National Transportation Safety Board

Safety Recommendation

Date: October 7, 1998

In reply refer to: A-98-87

Figure 1. Piper PA-31 Main Landing Gear Door Assembly

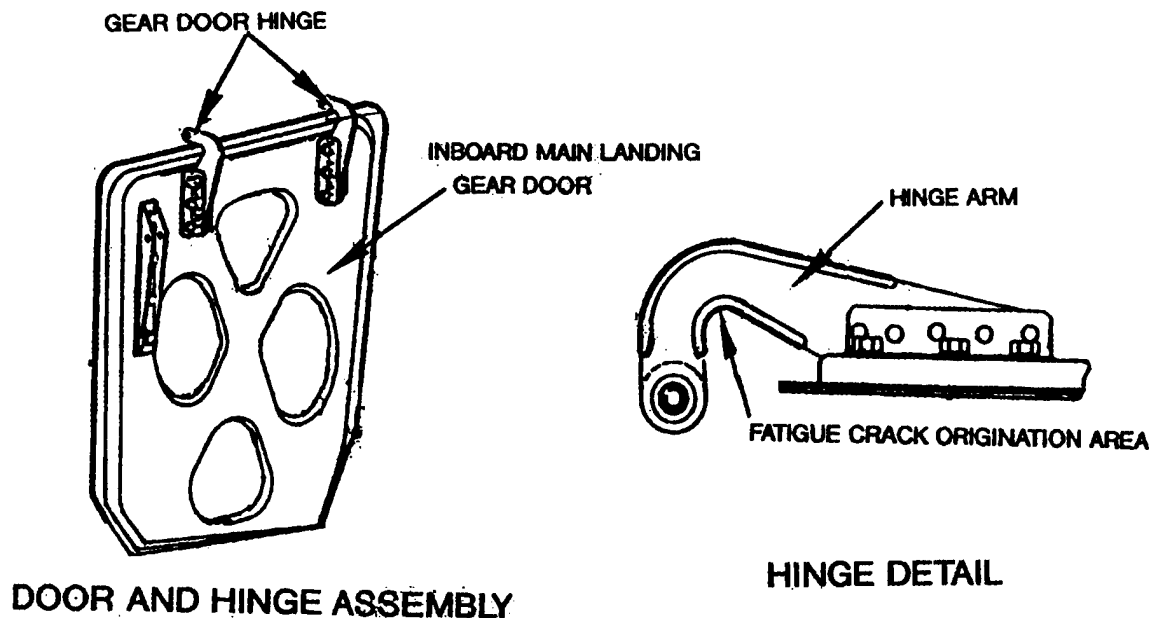
arm (see figure 1). The arm is subjected to cyclic loading during service, and the forging flash is a high-stress region of the hinge.

In 1980, following several incidents of fatigue cracks in the original hinge, Piper Aircraft Corporation (now New Piper Aircraft, Inc.) issued Service Bulletin (SB) 682, which recommends inspection of the PA-31 MLG inboard door hinge assemblies and hinge attachment angles for cracks within the first 100 hours of operation or during the next scheduled inspection, whichever occurs first, and every 100 hours thereafter unless/until an acceptable replacement part is installed. The SB recommends that all cracked door hinges be replaced with the improved P/N 47529-32 hinge assemblies before further flight. Upon installation of the improved hinge assembly, repetitive inspection of the hinge assembly is not required. On December 19, 1980, the Federal Aviation Administration (FAA) issued Airworthiness Directive 80-26-05, mandating the actions specified in this SB.

Figure 1. B.F. Goodrich 2-1203 Disk Brake Assembly

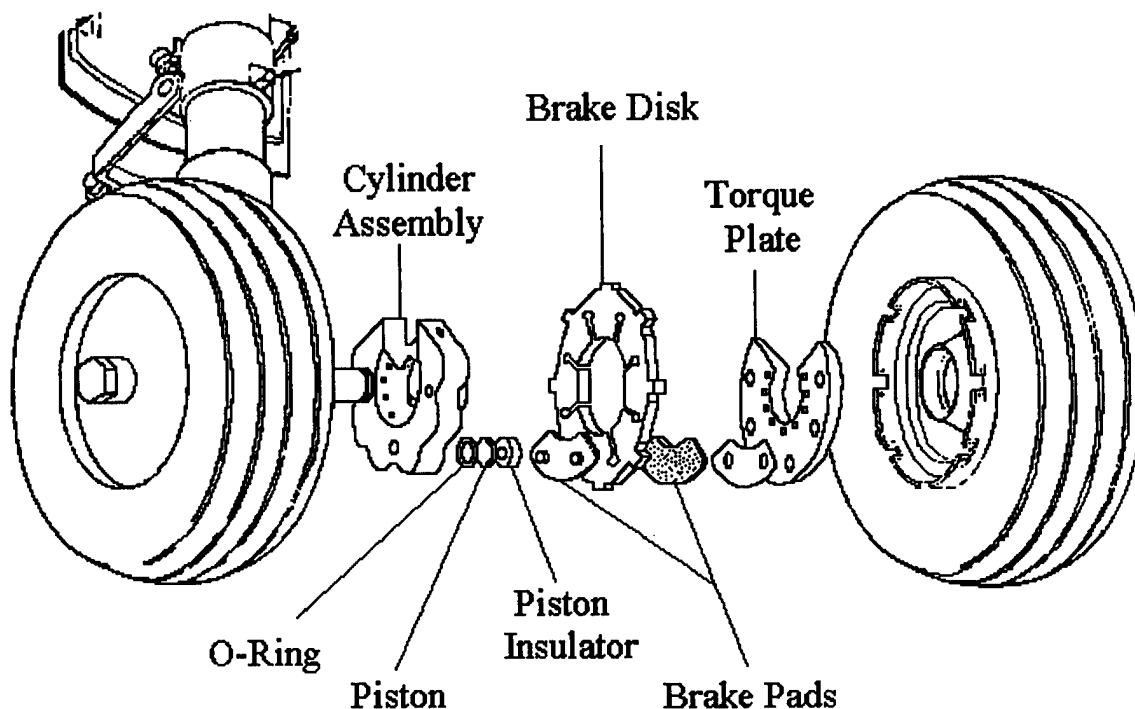
The airplane involved in the Montreal accident was equipped with B.F. Goodrich part number (P/N) 2-1203 wheel brake assemblies (see figure 1).² The left wheel well included the

The preliminary results of the investigation revealed that, during the takeoff roll, the flightcrew applied the right rudder because the airplane was apparently veering toward the left side of the runway. Approximately 13 minutes after takeoff, the flightcrew noted a loss of hydraulic pressure and the illumination of multiple warning lights, including the left wing overheat warning light. Meanwhile, a passenger reported that the left engine was on fire. The captain later reported that the fire was extinguished and that the back of the engine appeared to have exploded. However, while executing the instrument approach, approximately 1 minute before impact, the flightcrew reported that the fire had resumed. The flightcrew manually extended the landing gear after descending through 1,000 feet, shortly before the left wing failed.

Figure 1.—B-757 Off-Wing Escape Slide Assembly

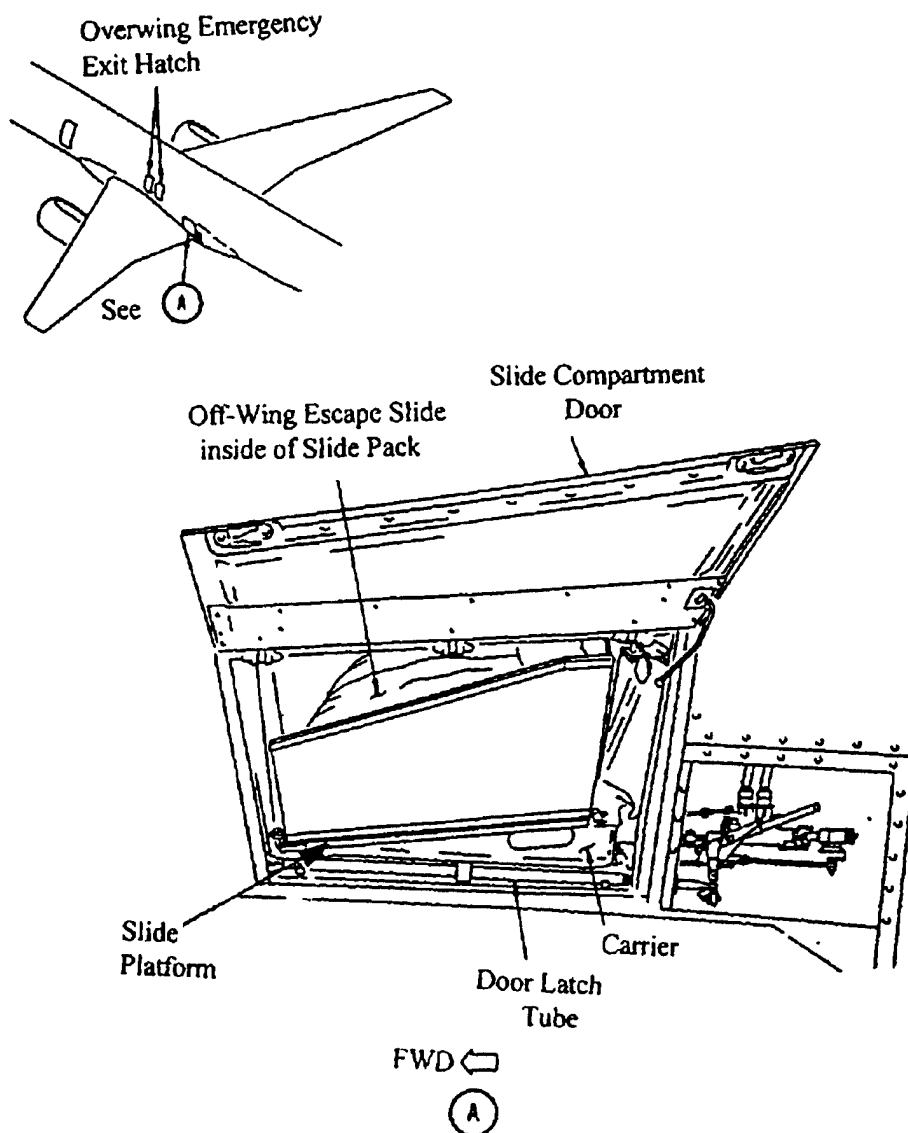
After the airplane landed, a Delta Airlines mechanic performed a walk-around inspection. During the inspection he saw that the left off-wing emergency escape slide had separated from the airplane, the left side of the fuselage aft of the slide was damaged, the slide was missing, and the restraining hook that mounted to the slide platform was broken, which allowed the platform to over-rotate, causing damage to the wing and fuselage (see figure 1). The slide carrier, the platform, and the door latching tube remained with the airplane. Further inspection found significant damage to the left side of the fuselage aft of the trailing edge of the left inboard flap.

down position, stating that "it took several attempts to move the actuator handle to the latched position." The mechanics stated that after the door was latched one mechanic ran his finger around the door to ensure it was closed, and then both mechanics checked the EICAS in the cockpit to ensure that the door was closed. One of the two mechanics said that he had received instructions on how to replace the slide about 4 or 5 years ago during a 2-week B-757 initial maintenance training class that provided instructions on all B-757 systems. The other mechanic had not yet received training on the B-757 off-wing escape slide replacement during his 3 months of employment at Delta.

Figure 1. Cross section of CF6-50 engine and expanded view of LPT module

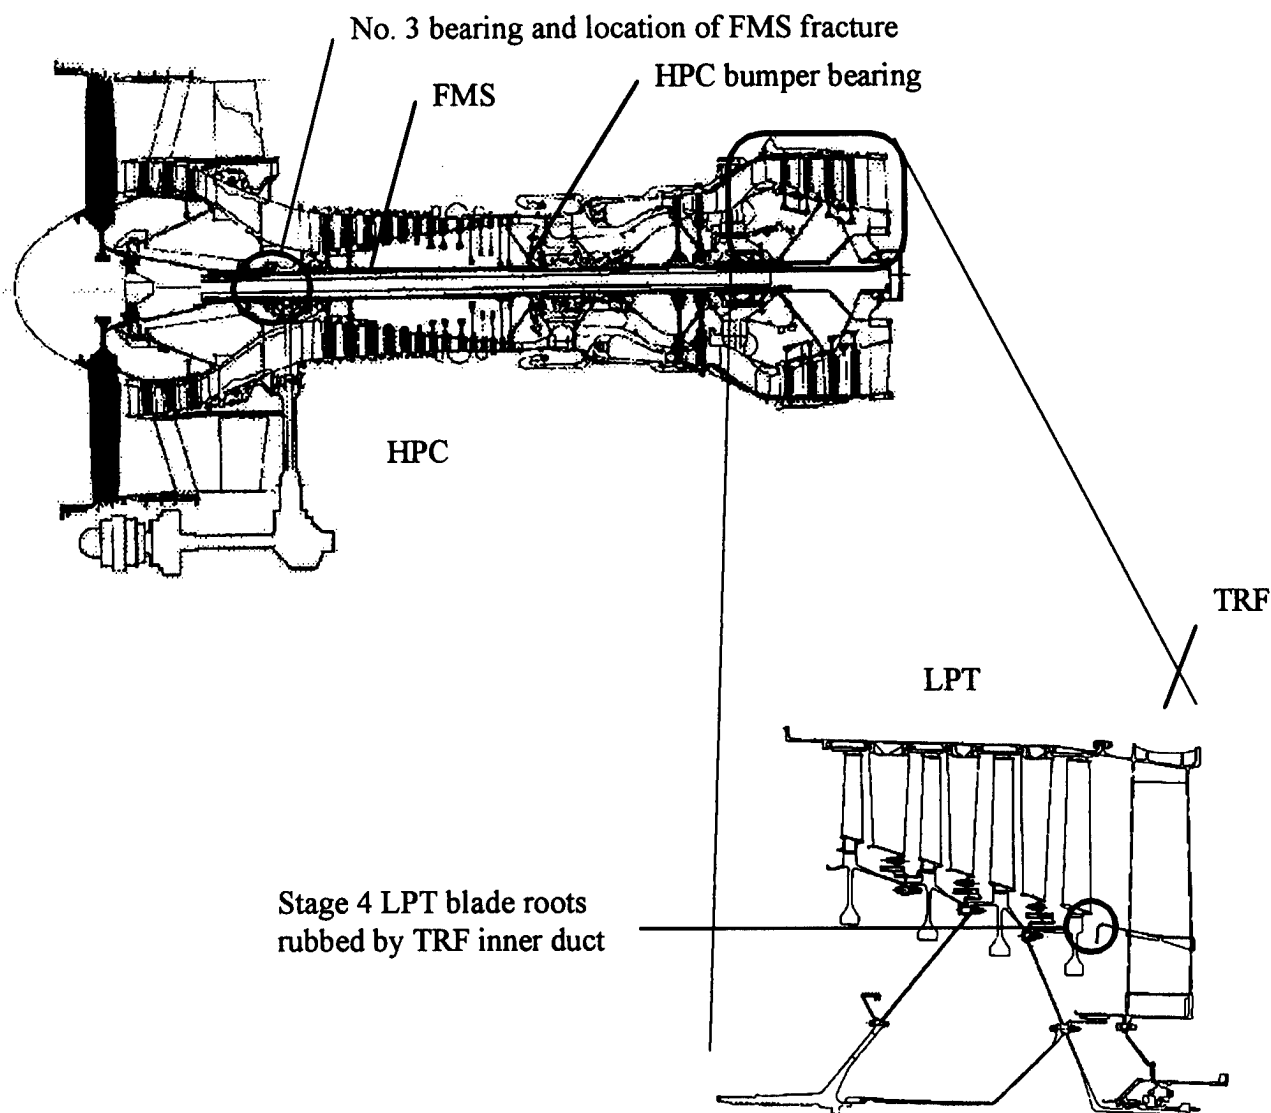
The examination of the No. 2 engine revealed that most of the LPT module was missing (see figure 1). The airplane had punctures to its left wing leading edge slats and to a landing gear door. In addition, the No. 1 engine had hard body impact damage⁴ to 18 of the 38 fan blades, and the fan cowl had impact damage from the debris ejected from the No. 2 engine.

Disassembly of the engine, serial number (SN) 455-954, at GE's Engine Maintenance Center, Ontario, California, under the direction of the National Transportation Safety Board, revealed that the fan midshaft (FMS) was fractured circumferentially, just aft of the No. 3 (roller) bearing. Although the No. 3 bearing was damaged, the damage was typical of secondary damage that would have occurred late in the engine failure sequence.

Figure 2. Cross section of CF6-80C2 engine and expanded view of LPT module

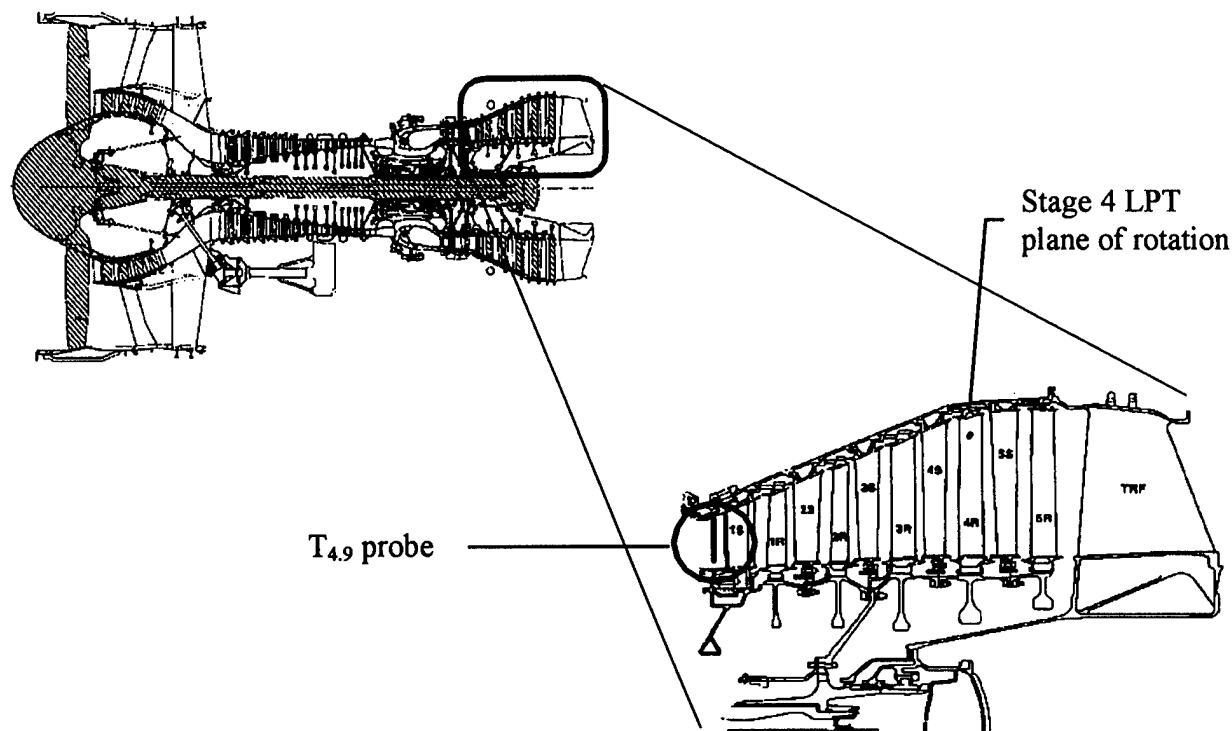
The engine was disassembled and examined under the direction of the Safety Board at Motoren-und Turbinen-Union (MTU), Hannover, Germany.¹⁵ The disassembly revealed that the tip of one interturbine temperature ($T_{4.9}$)¹⁶ probe had broken off and impacted one stage 1 LPT blade, causing a fatigue fracture of the airfoil near the blade tip shroud (see figure 2). All of the stage 2, 3, 4, and 5 LPT blades were found in their respective disks; however, all were fractured transversely across the airfoils at various lengths above the blade root platforms. The disassembly also revealed that the LPT case had a 17-inch by 2-inch wide hole in the stage 4 LPT plane of rotation. The damage to the LPT rotor was progressively worse along the gaspath, suggesting that the stage 1 LPT blade tip separated first, that all of the blades in the following stages were then fractured, and that the mass of material became larger as it progressed through the rotor, subsequently resulting in a case rupture in the stage 4 area.

The Safety Board is aware of a similar event that occurred on September 5, 1997, when a Federal Express (FedEx) McDonnell Douglas MD-11 airplane, equipped with GE CF6-80C2 engines, had an uncontained LPT failure in the plane of the stage 4 LPT rotor. The disassembly of the FedEx engine showed that a stage 1 LPT airseal segment had broken loose from the LPT case and passed through the gaspath causing the breakage of the downstream turbine blades. As in the American Airlines LPT, the damage in the FedEx LPT rotor was more extensive downstream along the gaspath. The evidence shows that both the American Airlines and FedEx LPT cases withstood the initial containment challenge of the separation of an LPT blade; however, neither case could withstand the loads imparted by the resultant mass of broken LPT airfoils. This suggests that the design containment capability of the LPT case is inadequate.

Figure 1. Boeing 727 Main Landing Gear Assembly

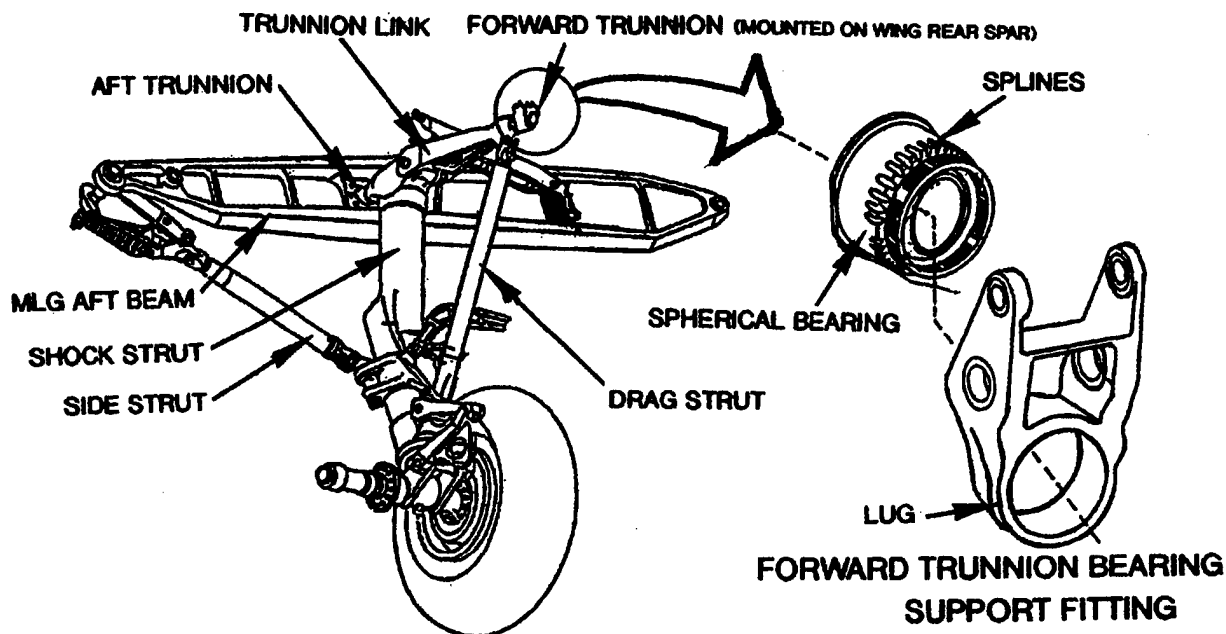
The right MLG of the B-727 is a conventional, two-wheel landing gear with three support points: the forward trunnion, the aft trunnion, and the side strut (see figure 1). A trunnion link is mounted between the shock strut and the rear spar. The aft end of the trunnion link is pinned to the shock strut, and the forward end pivots in a spherical bearing mounted in the forward trunnion bearing support fitting.¹ The spherical bearing has external splines that are used for locking the bearing assembly and retaining it within the support fitting lug. The splines contact a portion of the inner surface of the lug, leaving the gaps between the splines exposed to possible corrosion. The trunnion bearing support fitting is a round housing made from 4330M steel. The inner bore of the housing has chrome electroplating, which is the bore's primary means for corrosion protection. The fitting is mounted on the rear spar of the wing with high-strength bolts.

Examination of the trunnion bearing support fitting at the Safety Board's materials laboratory revealed corrosion at the forward edge of the fitting's lug in many of the exposed areas between the bearing splines. Fatigue cracking emanated from two locations within a severely corroded area, and intergranular stress corrosion cracking (SCC) stemmed from the fatigue cracking. This corroded area was 0.15-inch wide by 0.37-inch long by 0.07-inch deep. The fracture was caused by a combination of fatigue cracking and SCC.

Figure 1—Comparison of fuel selector handle locations in Long-EZ

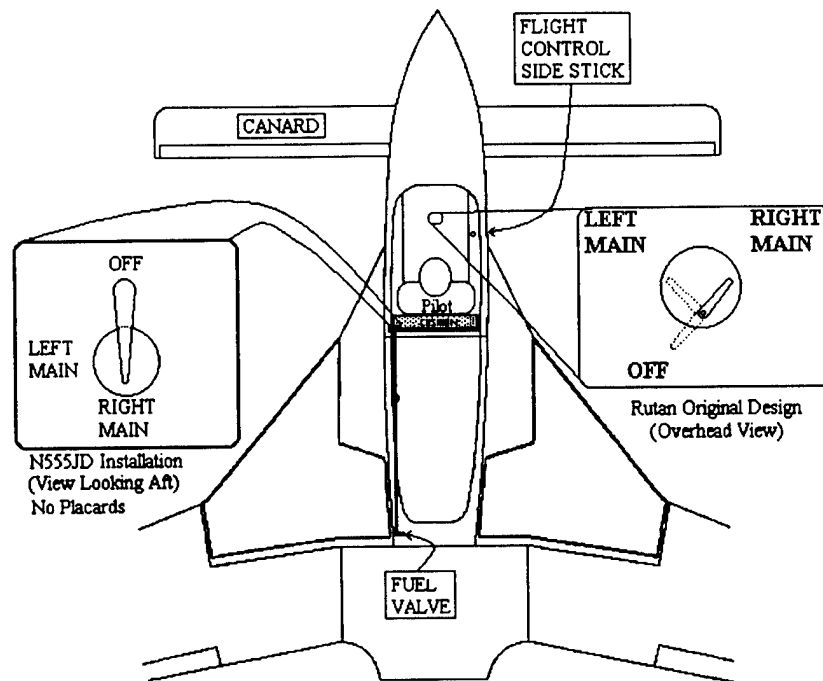
The amateur builder of N555JD modified the fuel system design by locating the fuel selector handle on the left side of the bulkhead that forms the front cockpit seat back. It was positioned approximately behind the front-seat pilot's left shoulder (see figure 1). The builder also changed the orientation of the handle so that upward selected "Off," right selected the left tank, and downward selected the right tank. The corresponding 3-position fuel selector valve was installed inside the rear cockpit on the front of the engine firewall just behind the rear seat and was connected to the selector handle via two torque tubes and a universal joint. The selector handle was about 4 feet forward of the fuel selector valve. No placard or marking existed (nor was it required) on the fuel selector handle base that would have indicated to the pilot its operating position. Further, as has been stated, the sight gauges were not marked to quantify the amount of fuel in the tanks.

Figure 1.—Seatbelt Assembly

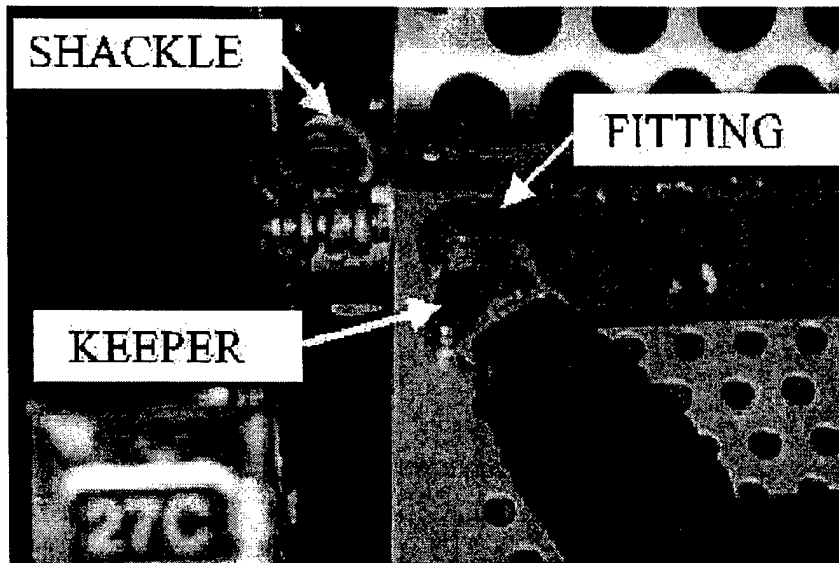
Both seatbelt assemblies are of a design commonly used in commercial airplanes. The seatbelt assembly consists of the standard release buckle, webbing, and an attachment fitting with a spring clip keeper at each end of the belt (see figure 1). The attachment fitting clips over a shackle that is bolted to the seatframe.

The Safety Board has previously addressed the issue of seatbelts becoming unhooked. During its investigation of a British Aircraft BAC-1-11 that encountered severe turbulence near Orlando, Florida, on May 24, 1988, the Safety Board found that three passenger seatbelts had detached during the turbulence. The passengers were displaced in their seats and sustained minor injuries. Safety Board investigators and Civil Aeromedical Institute (CAMI) engineers conducted tests at CAMI to identify ways that seatbelt attachment fittings could detach from the shackles bolted to the seatframes. The tests revealed that when the bolt used to fasten the shackle to the seatframe is overtightened, the shackle cannot move vertically to self-center, preventing the seatbelt end fitting from centering on the shackle. When this condition occurs, the end fitting cannot align with the seat occupant, and minimal side loads can force open the end fitting's spring-loaded keeper and detach the end fitting from the shackle.

Figure 1. JT8D engine

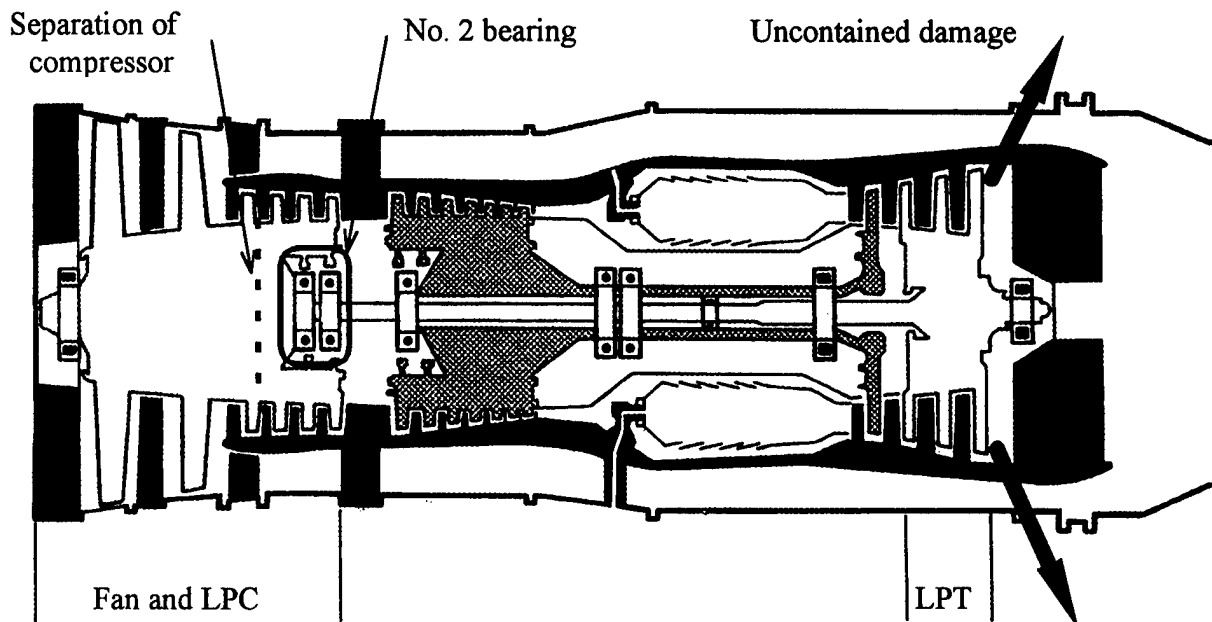
The JT8D engine's low pressure rotor system is made up of a two-stage fan, which consists of the 1st and 2nd stage fan rotors,³ and a four-stage low pressure compressor (LPC), which consists of the 3rd, 4th, 5th, and 6th stage compressor rotors. The two-stage fan and four-stage compressor are joined to the three-stage LPT, which consists of the 2nd, 3rd, and 4th stage turbine rotors, by a drive shaft, all of which rotate as one unit under normal conditions (see figure 1). The examination of the incident engine revealed that the 1st and 2nd stage fan rotors and the 3rd stage compressor rotor rotated together but independently from the remainder of the low pressure rotor system from the 4th stage compressor rotor rearward. The examination also showed that the 2nd, 3rd, and 4th stage LPT disks were intact but that all of the LPT blades were fractured adjacent to the blade root platforms, and most of the LPT vanes were missing. Although the engine was outfitted with an LPT containment shield, as required by Airworthiness Directive (AD) 94-20-09, the containment shield was broken into three pieces, and the engine was cut in two just aft of the LPT by liberated LPT blades.⁴
